Response to
Request for Additional Information No.569, Supplement 1

U.S. EPR Standard Design Certification
AREVA NP Inc.
Docket No. 52-020
SRP Section: 06.02.02 – Containment Heat Removal Systems
Application Section: 6.2.2

Question 06.02.02-136:**Follow-up to RAI 498, Questions 6.2.2-113 and 6.2.2-116.**

U.S. EPR Design Features to Address GSI-191

Figure 2.2.2.1—In-Containment Refueling Water Storage Tank System Functional Arrangement
Sheet 1 of 3

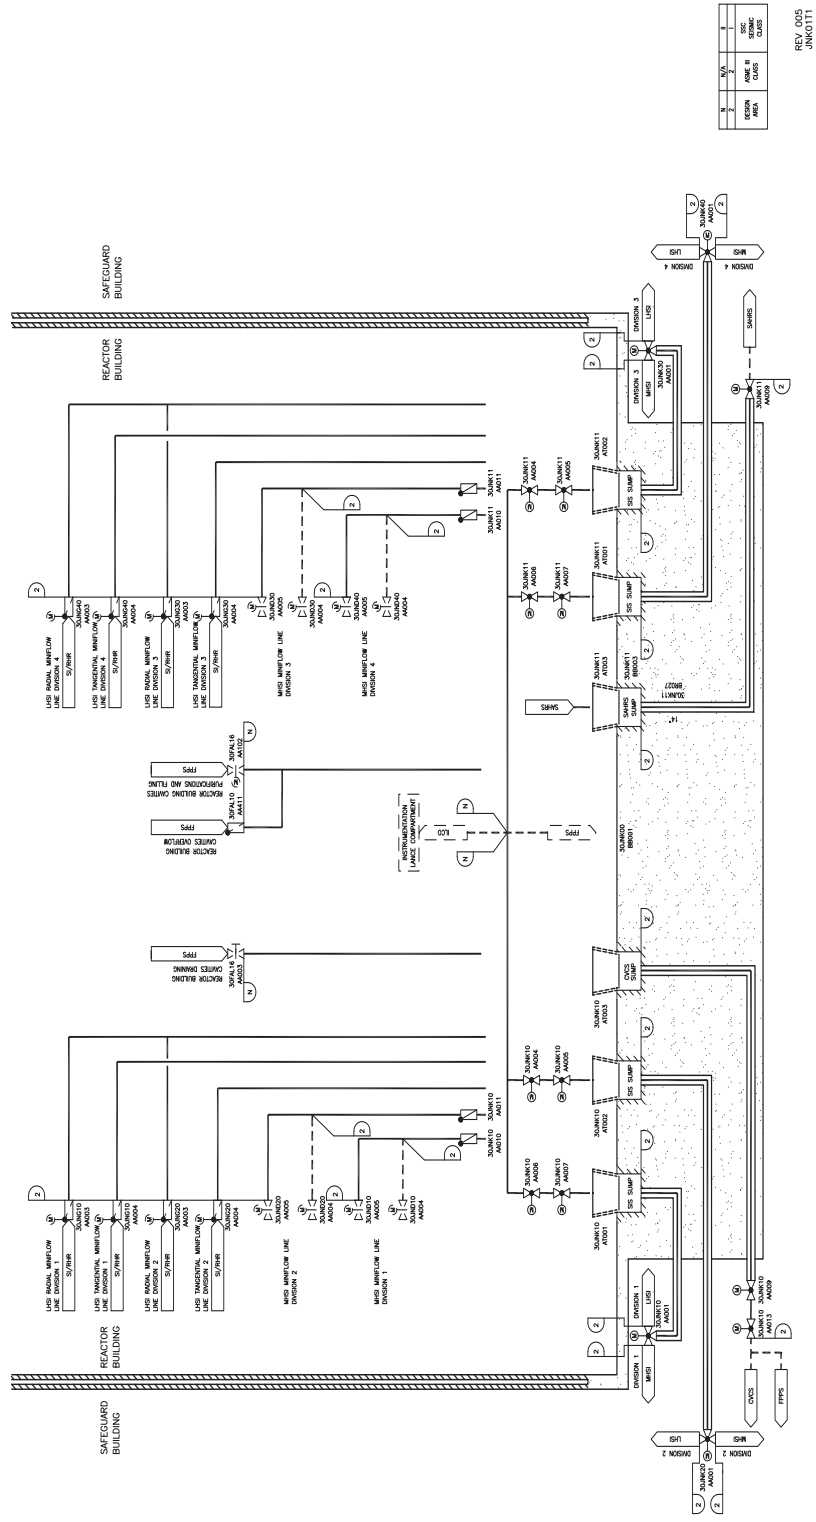
All the valves in Technical Report ANP-10293, Table G.2-1, Components in the ECCS Flow Path during an LBLOCA,” do not appear to be listed in DCD Tier 1 Table 2.2.3-1, “SIS/RHR Equipment Mechanical Design.” Since ITAAC 3.1 in DCD Tier 1 Table 2.2.3-3 concludes that ECCS pumps and valves in Tier 1 Table 2.2.3-1 are functionally designed and qualified under design basis accident conditions, then all pumps and valves in the ECCS flow path during SBLOCA and LBLOCA operations should be listed in the Tier 1 Table 2.2.3-1. Staff requests AREVA to ensure that all valves in the ECCS flow path are identified in Tier 1 Table 2.2.3-3 or provide justification why the valves should not identified in this table.

U.S. EPR FSAR Tier 1, Table 2.2.3-1—SIS/RHRS Equipment Mechanical Design, and Table 2.2.2-1—IRWSTS Equipment Mechanical Design, will be revised to include valves listed in Technical Report ANP-10293, Table G.2-1, “Components in the ECCS Flow Path during a LBLOCA.”

Some valves in the ECCS flow path listed in Technical Report ANP-10293, Table G.2-1, are part of the In-Containment Refueling Water Storage Tank System and are identified in U.S. EPR FSAR Tier 1, Table 2.2.2-1—IRWSTS Equipment Mechanical Design.

Conforming changes related to these valve additions will be made to U.S. EPR FSAR Tier 1, Section 2.2.2, Item 3.2, Table 2.2.2-3—In-Containment Refueling Water Storage Tank System ITAAC, Figure 2.2.2-1—In-Containment Refueling Water Storage Tank System Functional Arrangement, Figure 2.2.3-1—Safety Injection System and Residual Heat Removal System Functional Arrangement, and U.S. EPR FSAR Tier 2, Table 3.2.2-1—Classification Summary.

U.S. EPR FSAR Tier 1, Section 2.2.2, Item 3.2, Table 2.2.2-1, Table 2.2.2-3, Table 2.2.3-1, Figure 2.2.2-1, Figure 2.2.3-1, and U.S. EPR FSAR Tier 2, Table 3.2.2-1 will be revised as described in the response and indicated on the enclosed markup.

**Table 2.2.3-3—Safety Injection System and
Residual Heat Removal System ITAAC
Sheet 10 of 10**

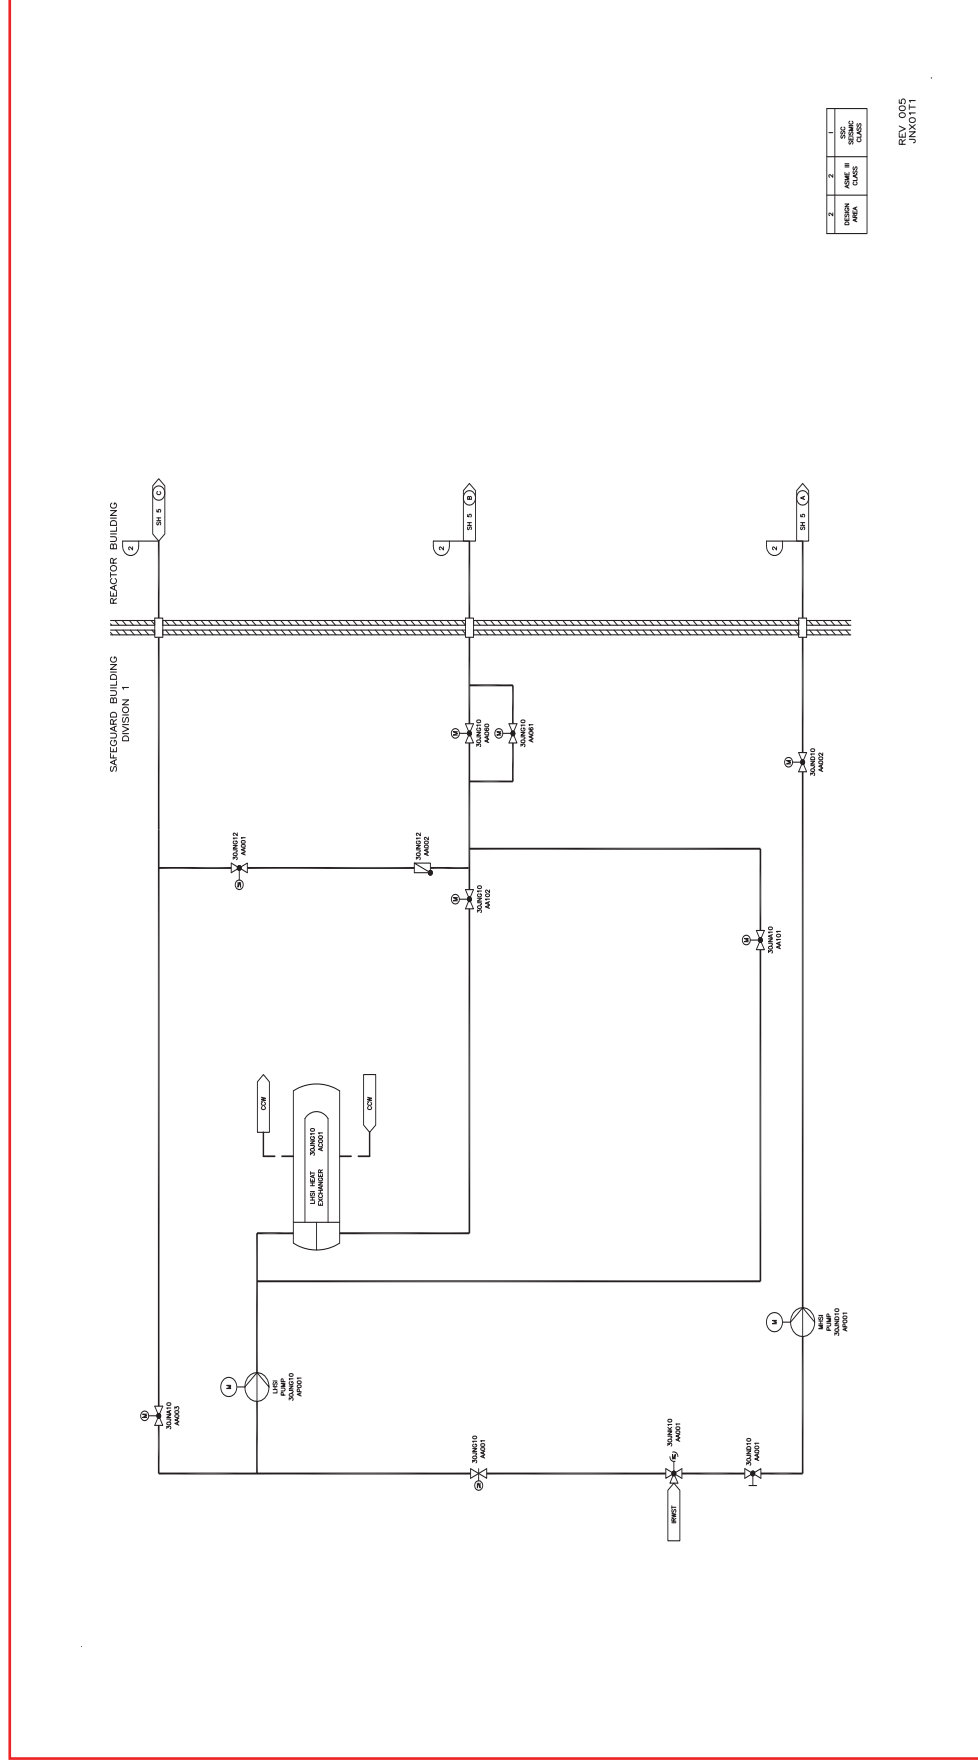
Technical Report ANP-10293, Section G.3.3.2, "Wear Rate Evaluation for Valves, Orifices and Pipes," describes the wear rate evaluation for valves, orifices and pipes during operation with post-LOCA fluids. In summary, Section G.3.3.2 states the following: The wear rate evaluation is performed using the post-LOCA fluid constituents listed in Technical Report ANP-10293, Table G.2.5 and the flow velocities listed in Technical Report ANP-10293, Table G.3-1. The vendor will provide tests and/or analysis to support acceptable wear rates of valves, pipes and orifices. In addition, an analysis will be provided to confirm that the overall system resistance/pressure drop across the ECCS is consistent with the safety analysis results for the 30 day mission time.

ITAAC 7.13 in DCD Tier 1, Table 2.2.3-3 provides confirmation that LHSI and MHSI system flow and wear rates are acceptable during operation with post-LOCA fluids. ITAAC 7.13 states, "A report concludes that pressure drop/ECCS is consistent with safety analysis results for 30 days of post-LOCA operation. A report concludes that wear rates are acceptable for 30 days of post-LOCA operation based on provided equipment specifications."

Staff requests AREVA to further describe the how the analysis described in Technical Report ANP-10293, Section G.3.3.2 will provide verification of acceptable ECCS operation at the end of the 30 day mission time when all components and piping reach their maximum wear. Provide sufficient detail of how vendor provided wear data of valves, pipes and orifices is used in the analysis.

Also, ITAAC 7.13, "Inspection, Test, and Analysis," states, "An analysis of plugging and wear of valves and orifices will be performed." Staff would consider the analysis of the ECCS operation to address the wear of all components in the ECCS system including the piping, not only the valves and orifices. Staff requests AREVA to discuss why only the wear of valves and orifices are addressed in ITAAC 7.13 and not all components in the ECCS system.

The general concern associated with erosive wear of pipes, orifices, and valves is increased system flow. Erosive wear may increase flow areas through the emergency core cooling system (ECCS); thus, reducing system resistance and increasing system flow. AREVA will provide equipment vendors with flow rates and debris profiles to perform testing and/or analysis to ascertain wear rate data for piping, valves, and orifices. Wear rate data provided by vendors will be conservatively used by AREVA to evaluate the potential increase in system flow caused by wear. This will demonstrate that ECCS flow rates remain within the maximum allowable system flow rate for at least 30 days of post-loss of coolant accident (LOCA) operation, as calculated in the hydraulic analyses performed in support of the FSAR Chapter 15 Safety Analyses.

U.S. EPR FSAR Tier 1, Table 2.2.3-3—Safety Injection System and Residual Heat Removal System ITAAC will be revised to include the following updated Inspections, Tests, Analyses for Item 7.13:

- a. An analysis of pressure drop/overall system resistance across ECCS will be performed.
- b. An analysis of plugging and wear rates of piping, valves, and orifices will be performed.

c. An analysis of plugging of ECCS instrument lines will be performed.

Commitment Wording	Inspections, Tests, Analyses	Acceptance Criteria
<p>7.13 LHSI and MHSI systems provide safety injection flow to the RCS during post-LOCA operation.</p> <div data-bbox="284 787 527 871" style="border: 1px solid red; padding: 2px; display: inline-block;"> RAI 569, Q. 06.02.02-138 </div> 	<p>a. <u>An analysis of pressure drop/overall system resistance across ECCS will be performed.</u></p> <p>b. An analysis of plugging and wear <u>rates of piping</u>, valves, and orifices will be performed.</p> <p>c. <u>An analysis of plugging of ECCS instrument lines will be performed</u></p>	<p>a. A report concludes that pressure drop/overall system resistance across ECCS is consistent with safety analysis results for 30 days of post-LOCA operation.</p> <p>b. A report concludes that wear rates are acceptable for 30 days of post-LOCA operation based on provided equipment specification.</p> <p>c. A report concludes that post-LOCA debris will not clog the ECCS instrument lines.</p>
